ADDENDUM NO. 2

RE: ADA Improvements To
Hartley Job Administration Building
Project No. 11-0416

This Addendum is intended to clarify/revise the plans and specifications per the following items:

A2.1

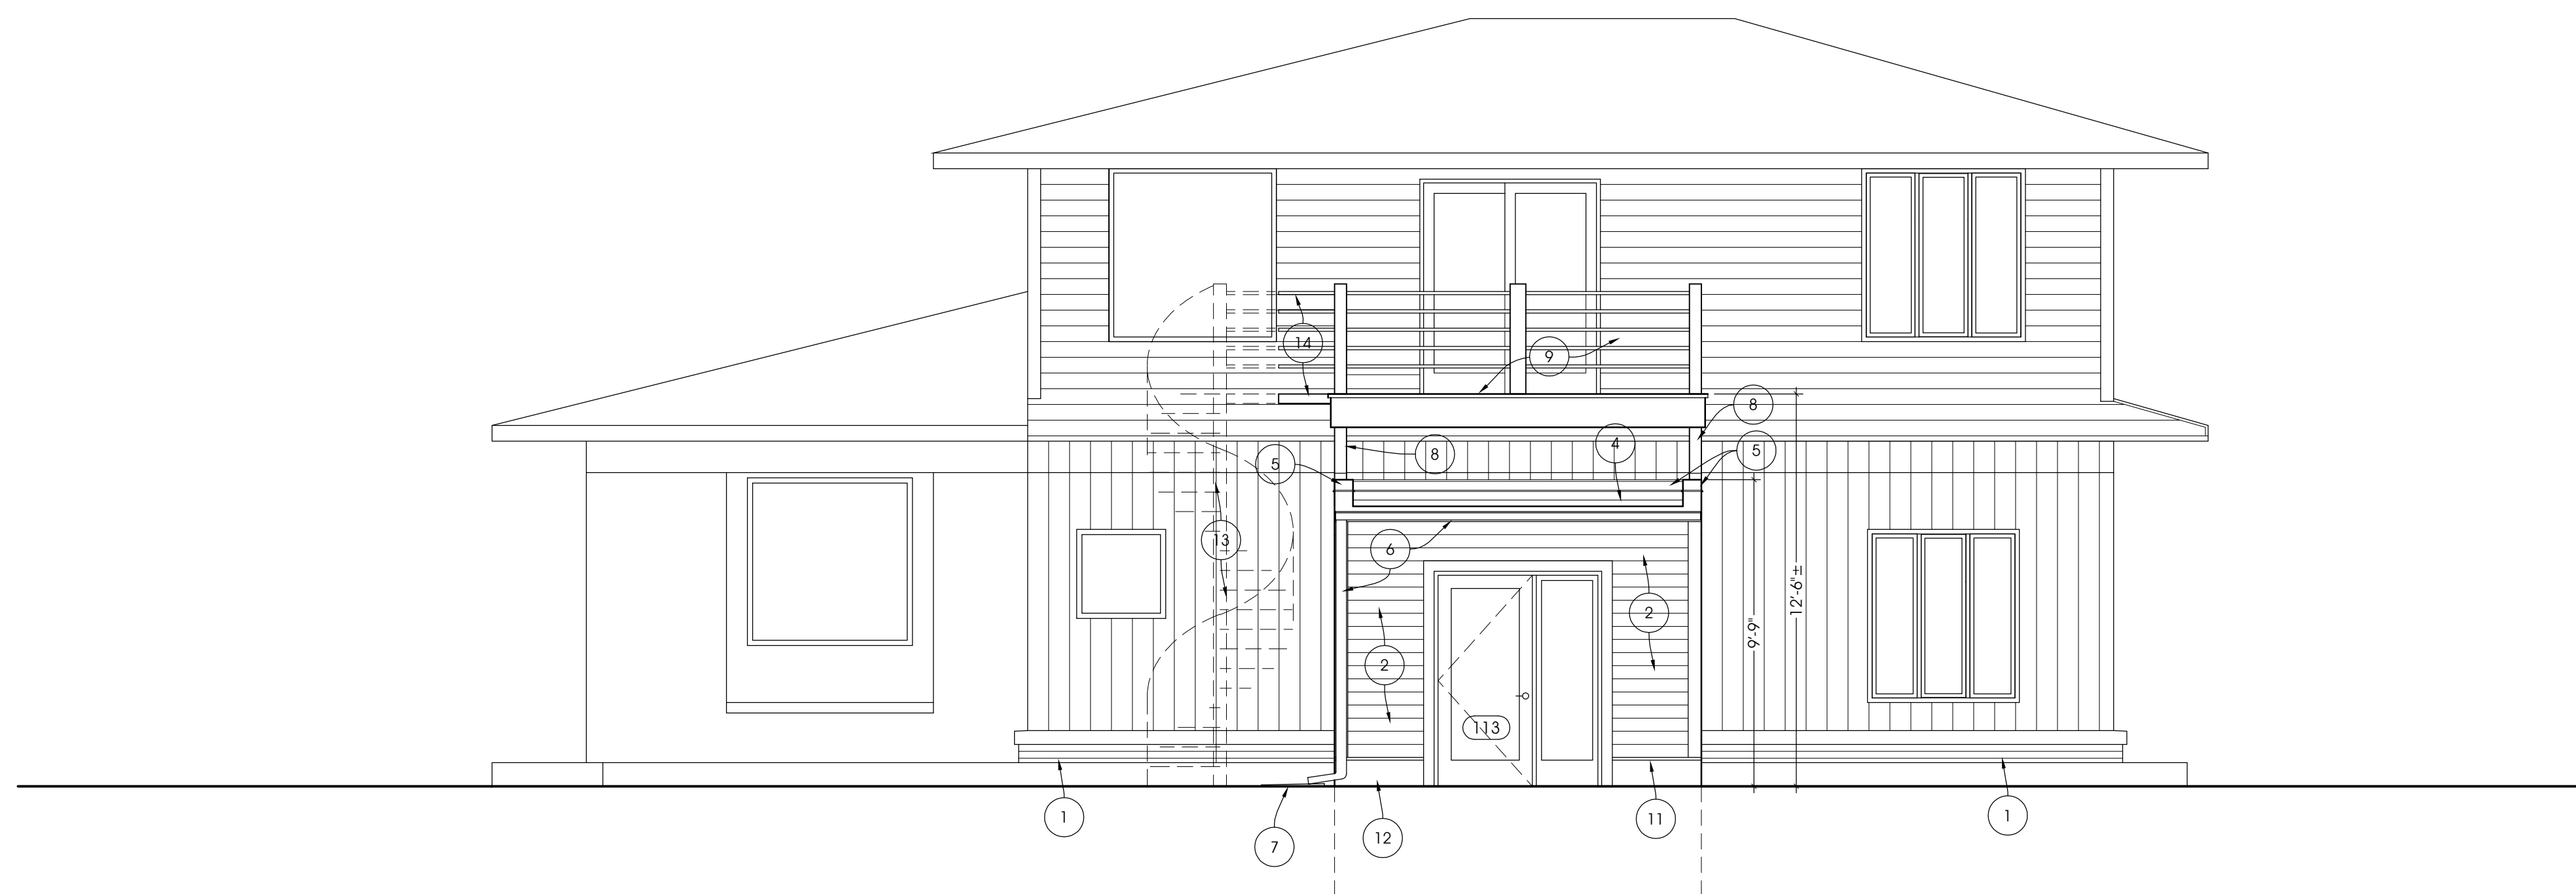
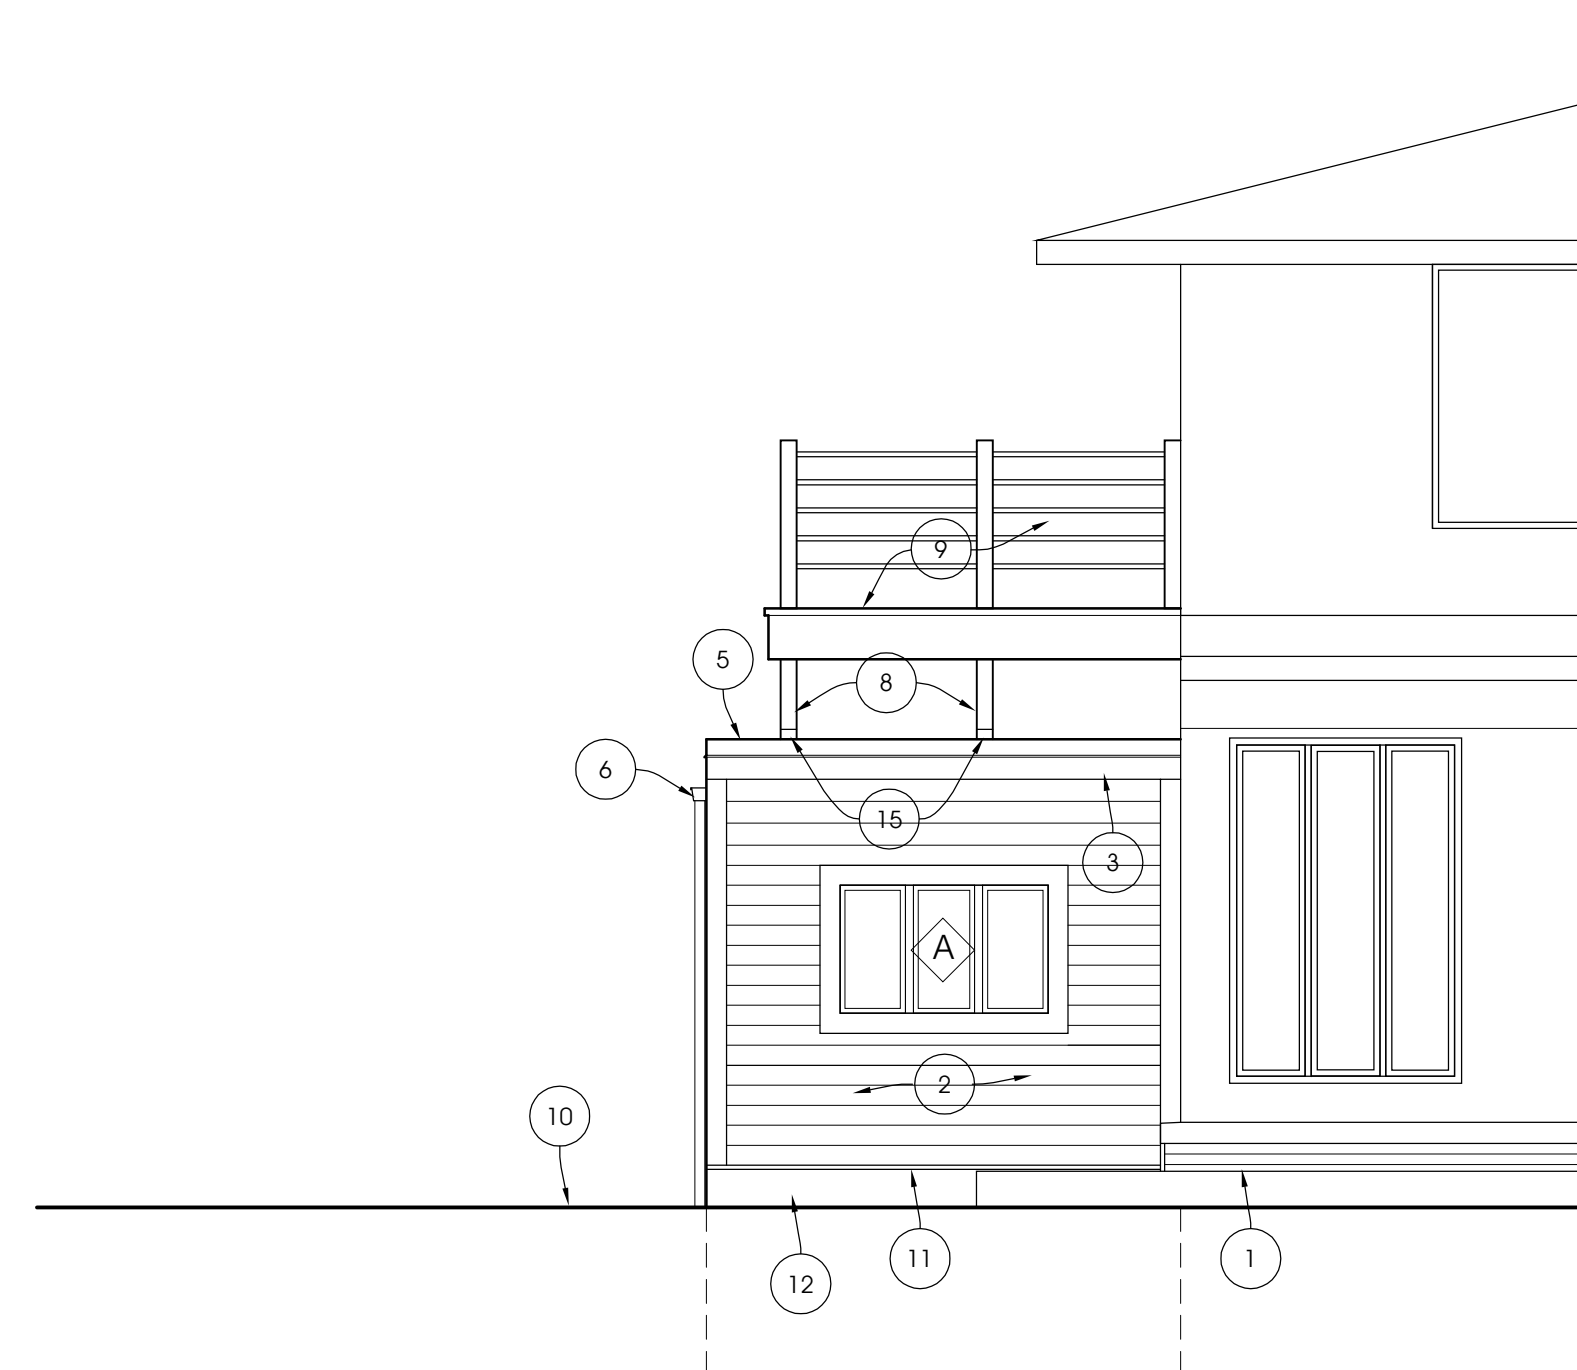
ITEM 4 – SHEET A2.1 – Exterior Elevations – Remove sheet replace with A2.1 under this Addendum No. 2, Clarification of keynotes, and building dimensions.
